No. 86-5

A. 170/190 Oil Pump Alignment Tool Modification
B. Changes to the 90-95693 Service Manual

Figure 1.

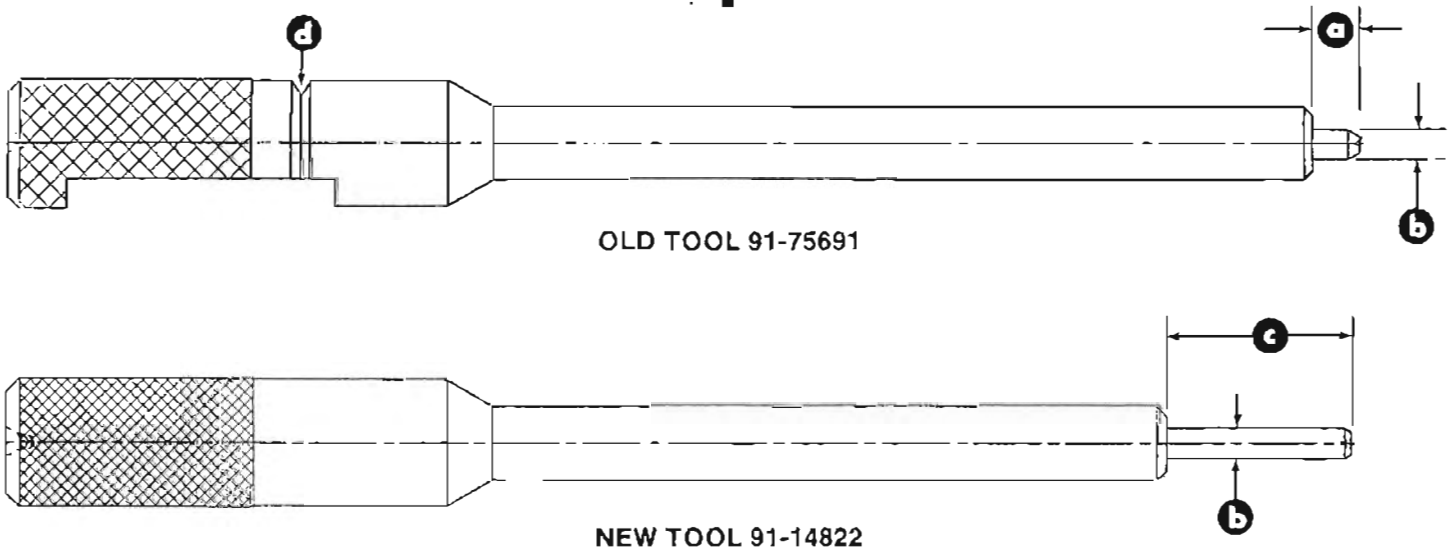
Later model MCM 170/190 engines will have a new design cast iron oil pump in place of the old style aluminum pump. The cast iron oil pump will need a new pump alignment tool as shown in Figure 1. This tool must be used with the cast iron pumps and may also be used with the aluminum pumps. The original pump alignment tool can be modified to work with the cast iron pumps using the dimensions shown in Figure 1.

NOTE: The depth groove is being removed from the new tool as it was not used for field service.

- a - .48" (12.19mm)
- b - .313" Dia. (7.95mm)
- c - 1.87" (47.49mm)
- d - Depth Groove - Removed on New Tool
